Discovery Point, Wollie Creek

Discovery Point, Woll Creek Concept Plan

Building 8 Envelope Parameters

Scale	1:250 @ A1 , 1:500 @ A3		
Drawn	AW	Checked	MA
Project no.	S11191		
Status	PLANNING		
Plot Date	3/06/2013 4:49:26 PM		
Plot File	C:\Temp\masterplan-discovery-111110_Central_WAY.rvt		
Drawing no.	DA3-010	Revision	F

Building 9 Envelope Parameters

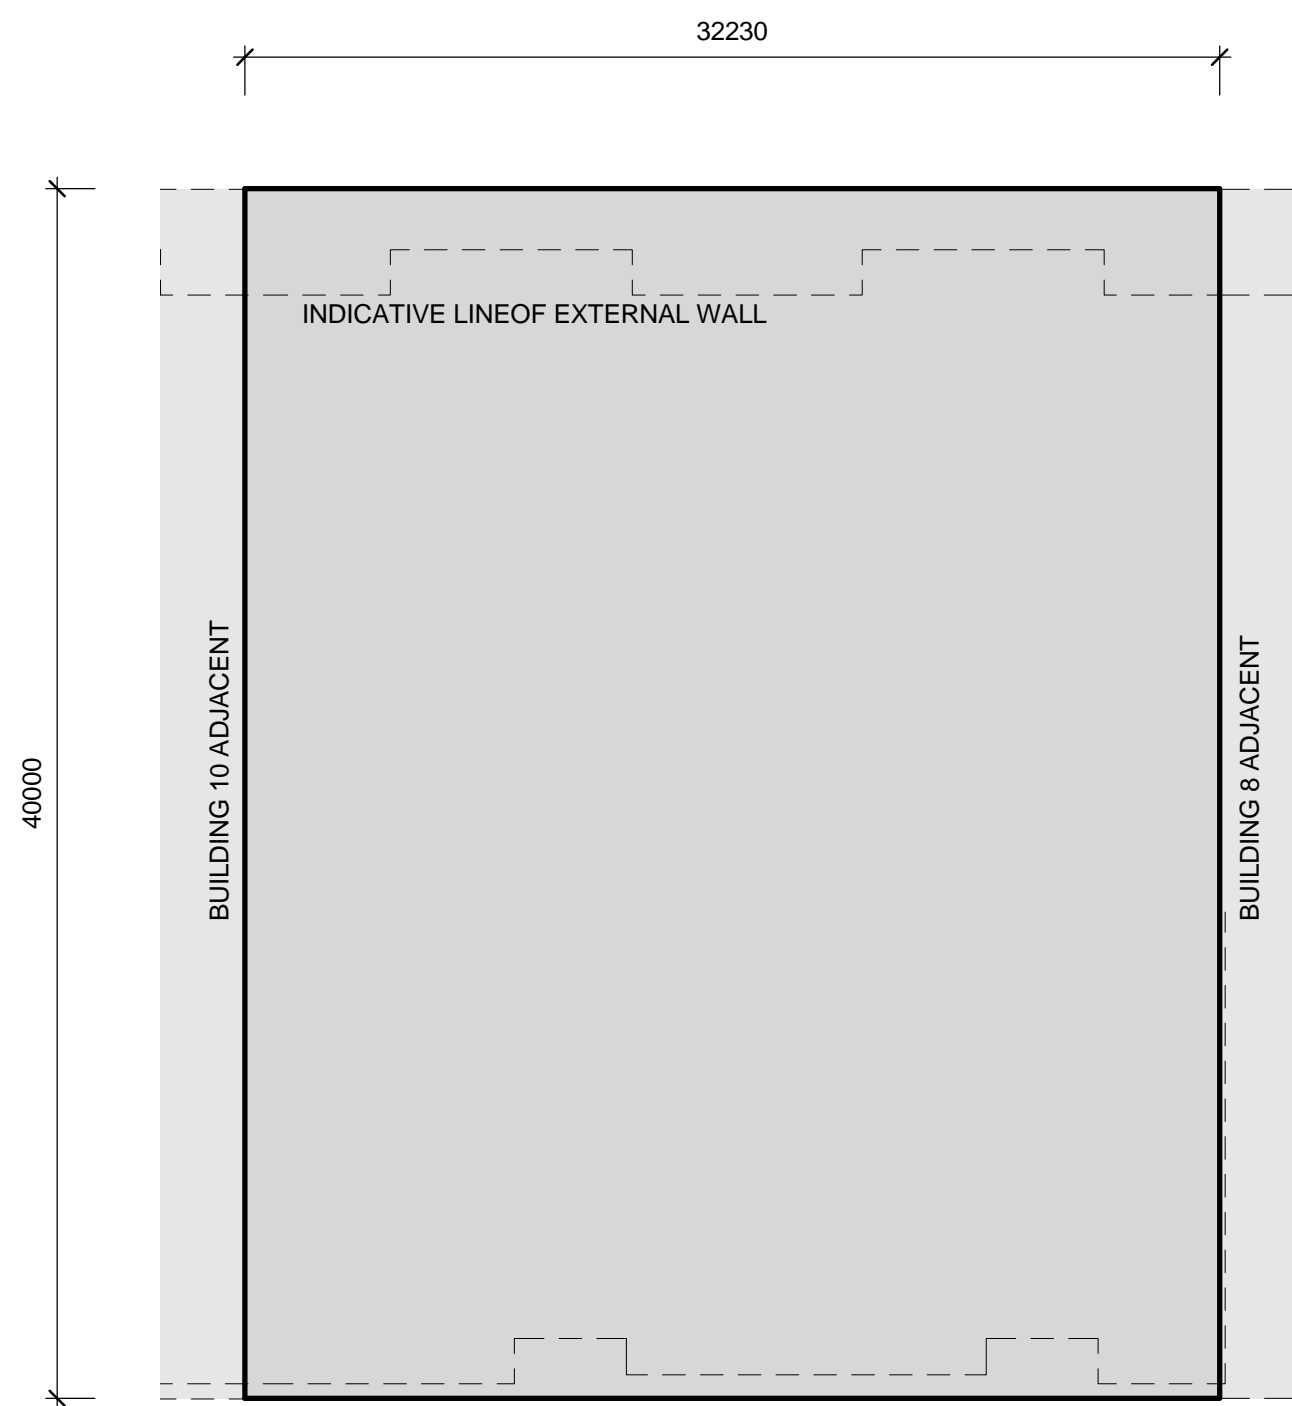
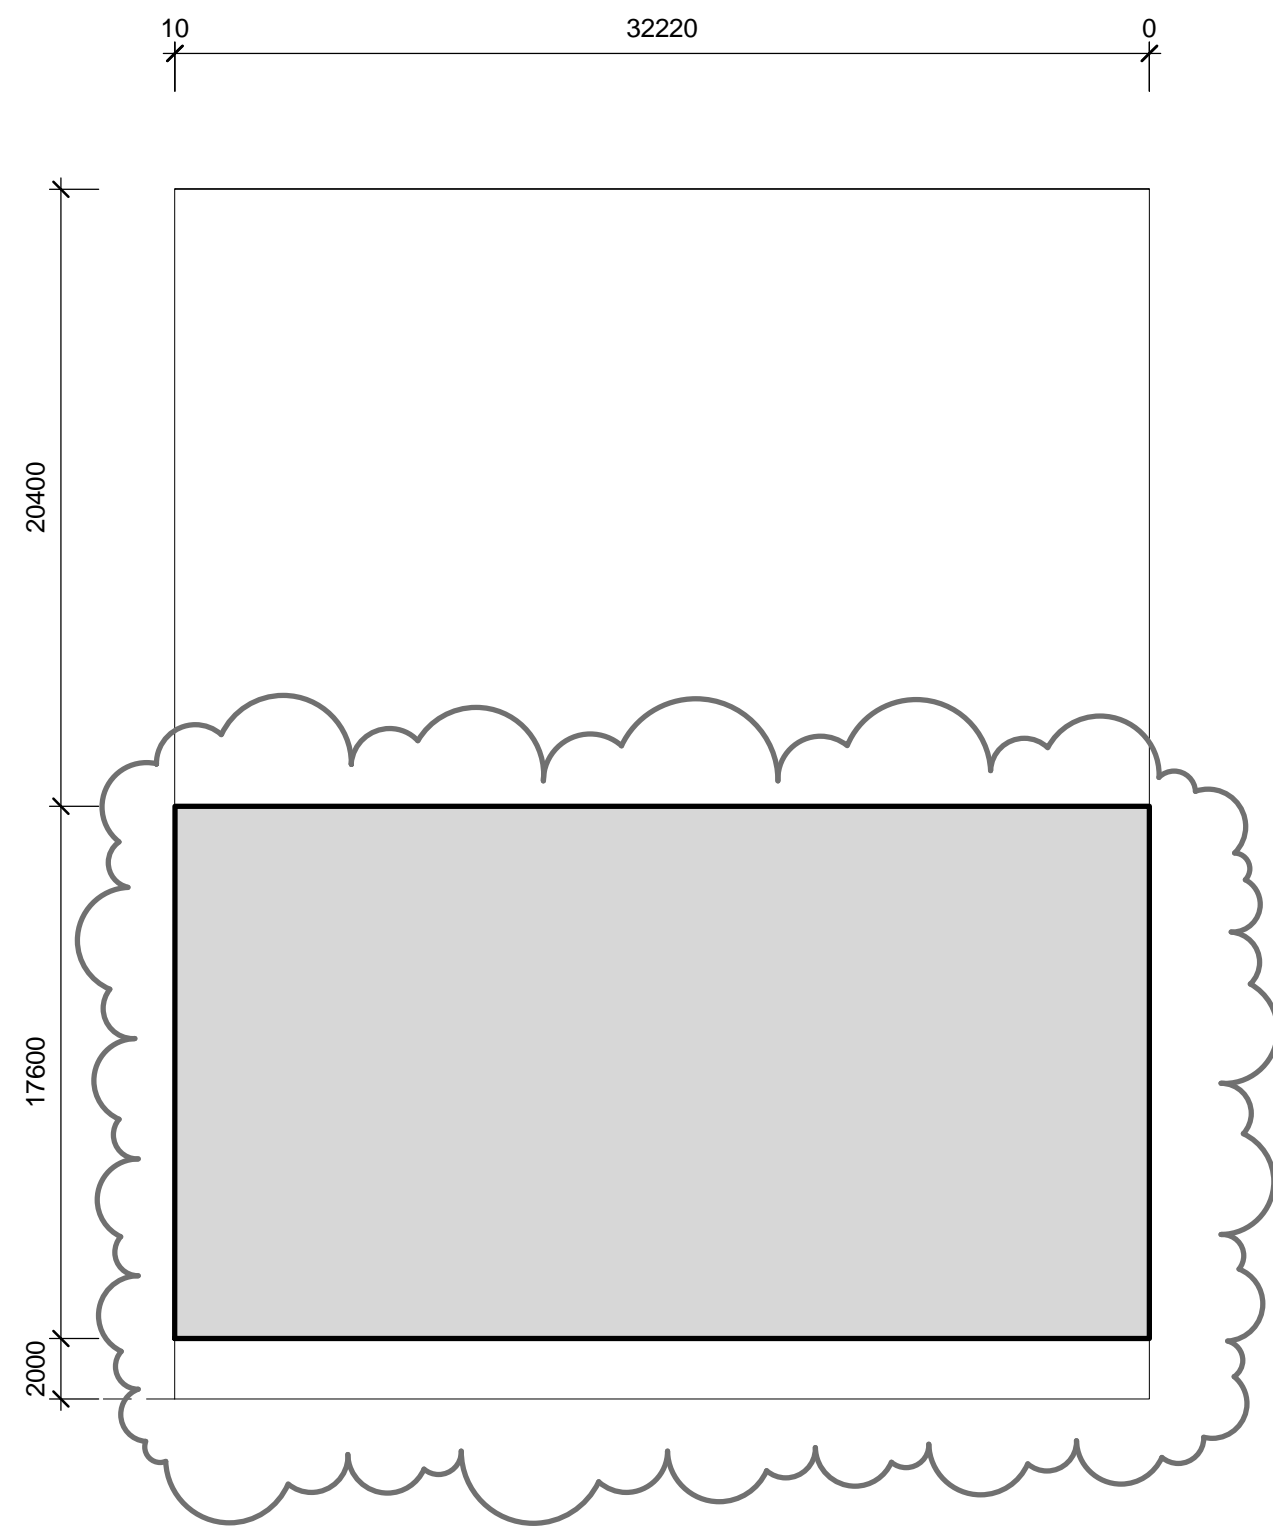
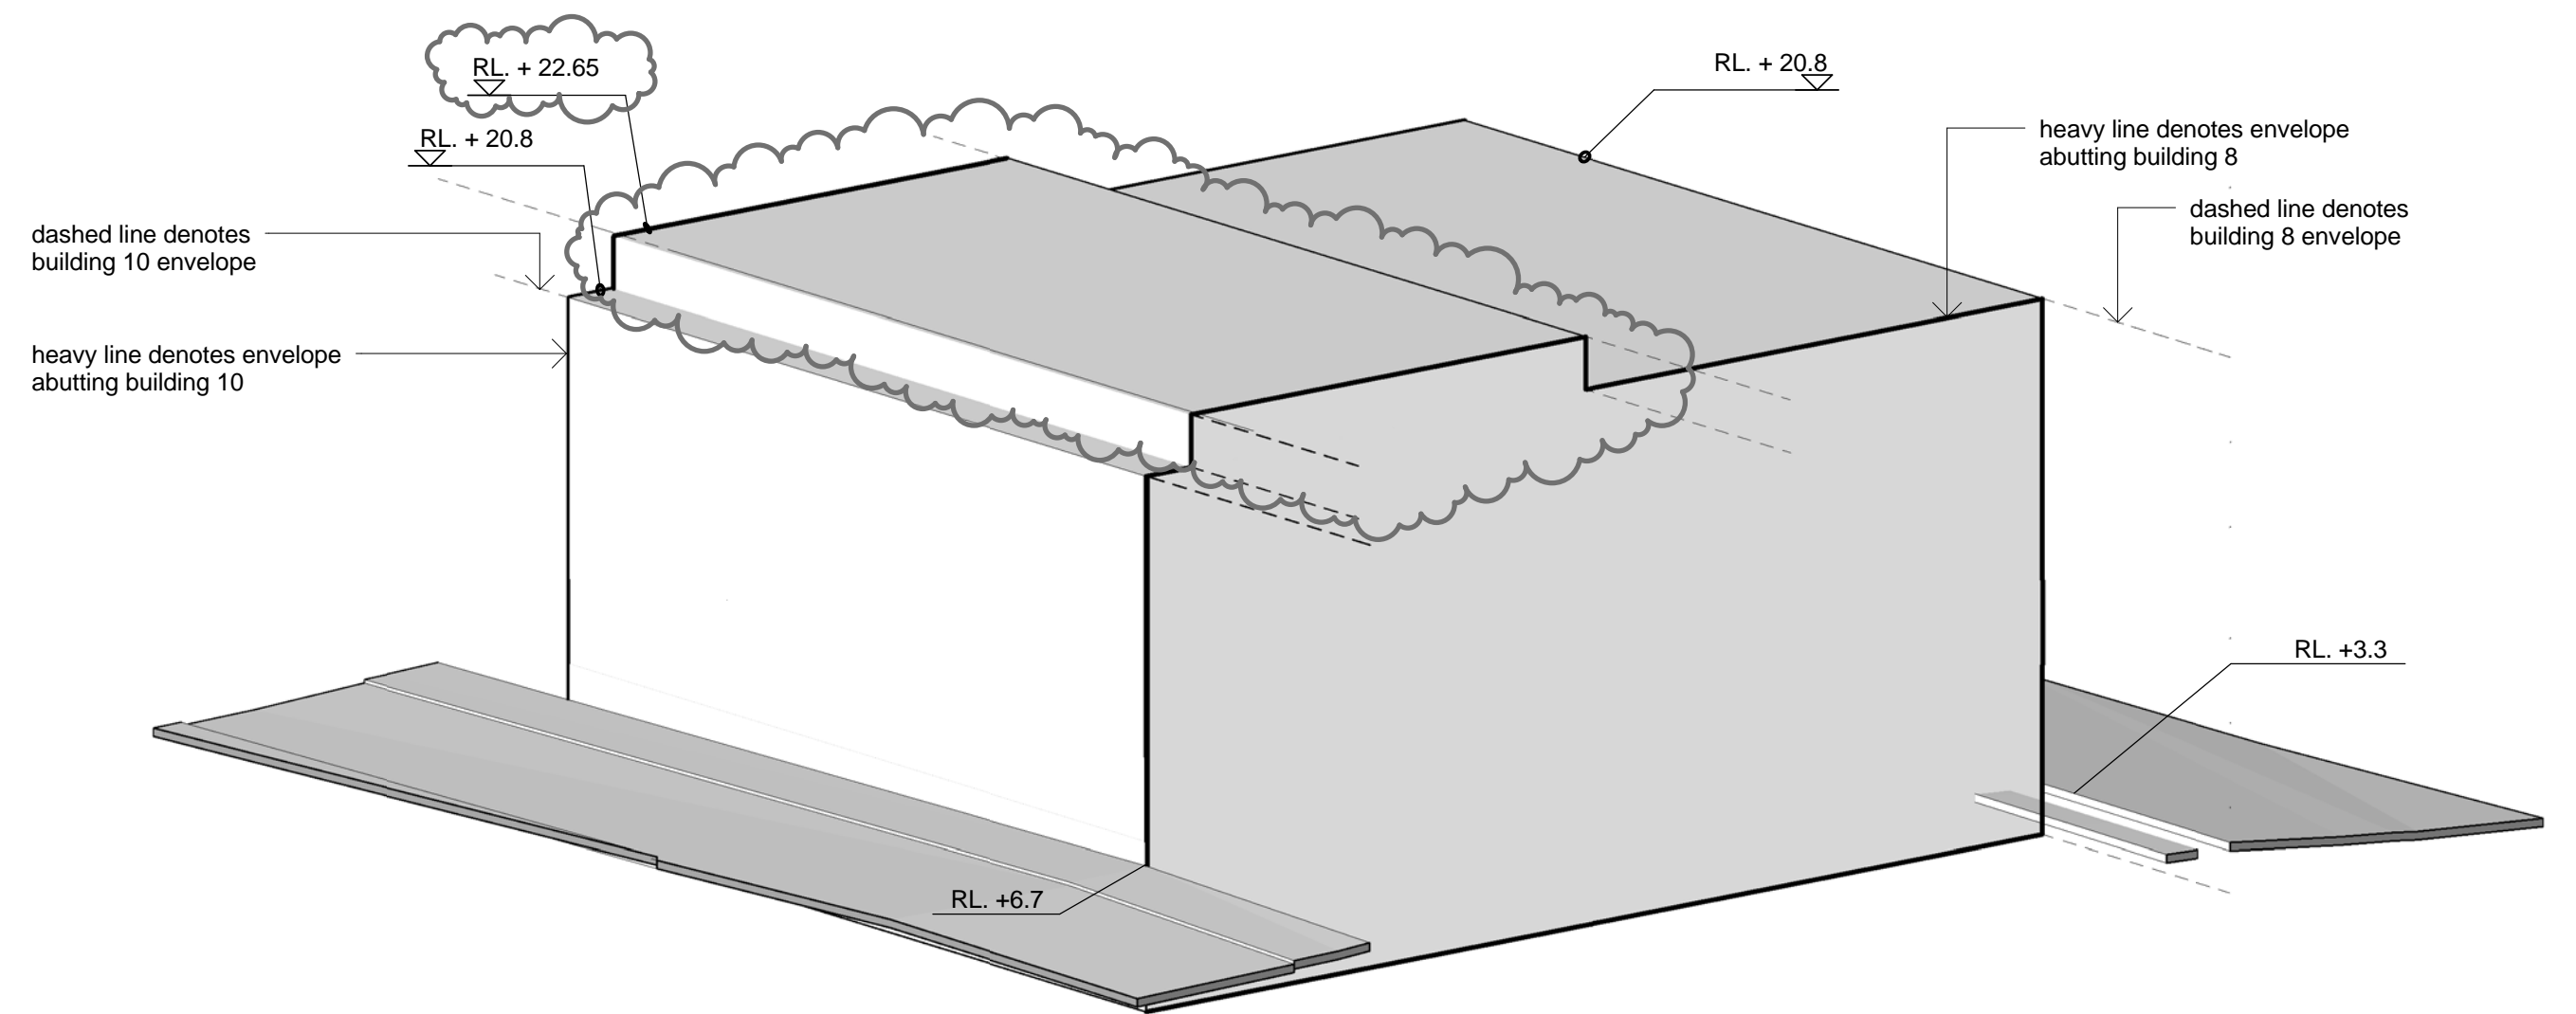
Amendments since Revision A
Envelope increased to include podium of building 4;
Envelope reduced at East to increase building separation
Setback to Cooks River Increased
